DEVELOPMENT AGENDA ITEM	
ITEM TITLE:  Central-Main Street Redevelopment Plan – Stormwater Review	AGENDA ITEM NUMBER: 5. A.  FILE NUMBER:  COMMITTEE AGENDA DATE: October 8, 2018  COUNCIL AGENDA DATE:
STAFF REVIEW: Tom Dabareiner, AICP	SIGNATURE SIGNATURE
APPROVED BY CITY ADMINISTRATOR:	SIGNATURE

SUBJECT: Central-Main Street Redevelopment Plan - City of West Chicago

(CBBEL Project No. 18-0376)

#### Review of Central-Main Street Redevelopment Plan

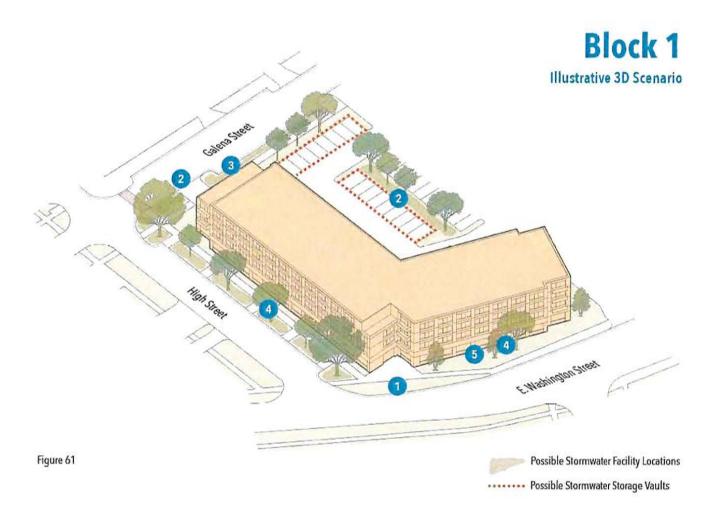
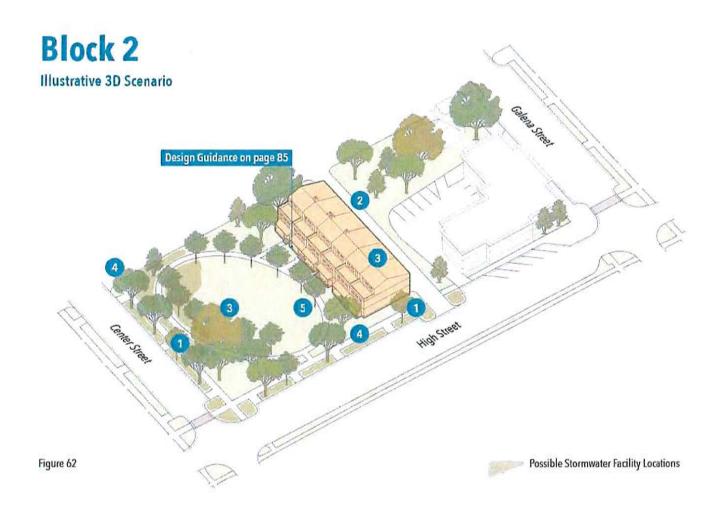
<u>CBBEL Recommendation</u>: CBBEL recommends that the areas identified in the plan as potential bioretention facilities be implemented as originally contemplated, as the site plan lends itself well to providing this storage in a cost-effective manner. Based on our review of the utility information for this area, there are currently no watermain, sanitary, or storm sewers located in these parkway areas, and therefore major utility relocations would not be necessary to accommodate these facilities.

Although not required as part of the development of Block 1, the PCBMP storage volume can be used to offset the stormwater management requirements of the other blocks. When PCBMP storage volume is provided in this manner, the volume can also be counted toward any detention volume that is also required. Therefore, the bioretention facility storage volume provided on Block 1 may count toward both the PCBMP requirements (Blocks 2, 3, 4, and 5) and the stormwater detention requirements (Block 4) of the other redevelopment.

Using the bioretention areas identified in the Plan and information on the existing storm sewer system in this location, a total storage volume of approximately 5,900 ft³ (0.14 acre-feet) of storage volume can be provided. The Plan also identified the potential of vault storage underneath the proposed parking lot area. While this is a feasible option, underground vault storage is expensive (approximately \$450,000/acre-foot) and therefore other options should be considered first. Based on the flat topography of the site, it appears that portions of the parking lot can be converted to permeable pavement. Using the footprint that was designated for underground vault storage, approximately 3,700 ft³ of additional storage volume could be provided in the aggregate layer of permeable pavement in this location.

#### **Block 3: Multi-Family Apartments and Townhomes**

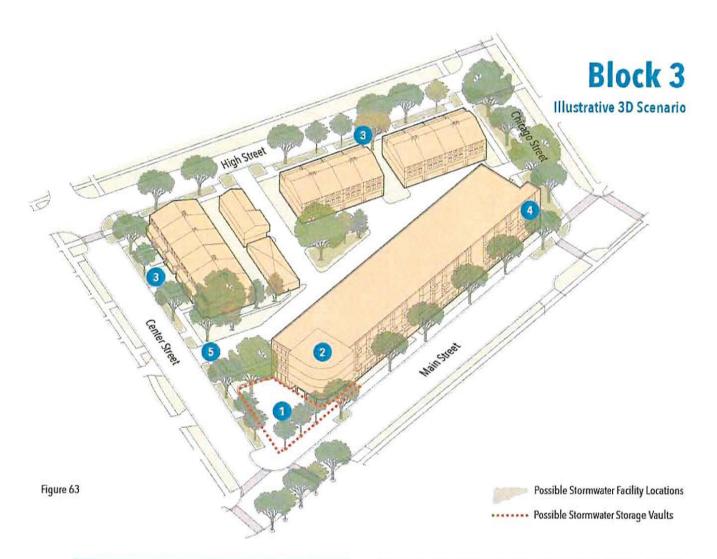
<u>CBBEL Recommendation</u>: Based on our review of the utility atlases for this area, there are no watermain, sanitary sewer, or storm sewers that would be in conflict of constructing bioretention areas in the parkways in these locations. Therefore, we concur with the Plan and recommend that these facilities be pursued as a cost-effective option. Using the bioretention locations identified in the plan and the existing utility information for this area, approximately 6,300 ft<sup>3</sup> of storage volume can be provided in this manner, which is slightly more than the required PCBMP volume for Block 3.

Since our calculations determined that Block 3 was slightly under the net new impervious rea threshold for detention, no stormwater detention is required for this development. The Plan identified the proposed plaza as a location for potential underground detention, and because

CBBEL recommends that the areas identified in the plan as potential bioretention facilities be implemented as originally contemplated, as the site plan lends itself well to providing this storage in a cost-effective manner. Based on the utility atlases provided by the City, there are currently no watermain, sanitary, or storm sewers located in the parkways areas of High Street and Center Street, so major utility relocations would not be necessary to accommodate these facilities.

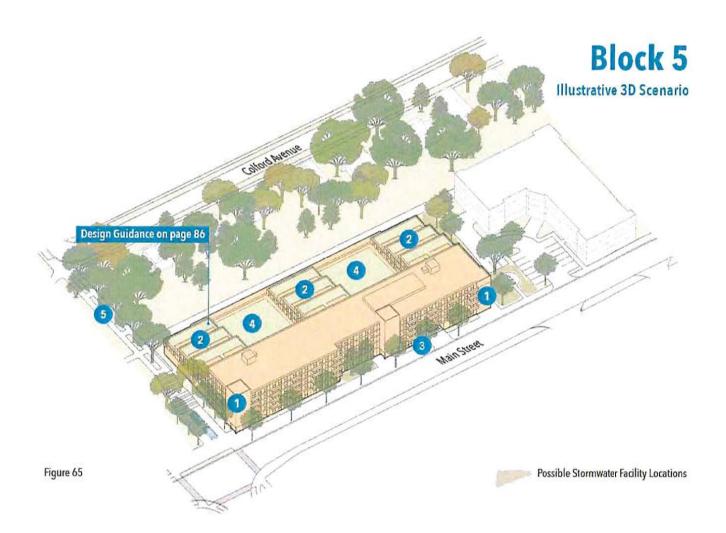
<u>CBBEL Recommendation</u>: Based on our review of the utility atlases in this area, there is an existing water main and sanitary sewer located along the northern part of Main Street and the northern parkway area. It is unlikely that infiltration practices can be constructed at the southwest corner of the site while maintaining the recommended offsets from these utilities. The eastern parkway of Chicago Street, as well as the landscaped areas of the courtyard, are good candidates for installing bioretention facilities. Approximately 8,700 ft<sup>3</sup> (0.20 acrefeet) of PCBMP storage volume can be provided in these locations, which would satisfy the PCBMP requirements for the site.

Because the proposed impervious area exceeds the net new impervious area threshold for detention by approximately 18,000 ft<sup>2</sup>, converting the parking areas to permeable pavement in itself would not drop the proposed development below the 25,000 ft<sup>2</sup> threshold. But based on site topography and the proposed site plan, the use of permeable pavement can provide

Since stormwater detention volume is required for Block 4, an underground storage vault can be provided in the parking lot areas of the central courtyard. In addition, it is possible that the underground storage vault can be configured with an open bottom and PCBMP storage volume can be provided in aggregate below the vault. This would eliminate the need for any bioretention/permeable pavement storage volume to satisfy the PCBMP requirements for Block 4. The storage vault/infiltration storage approach is the recommended approach since it would satisfy all stormwater management requirements as a single facility.
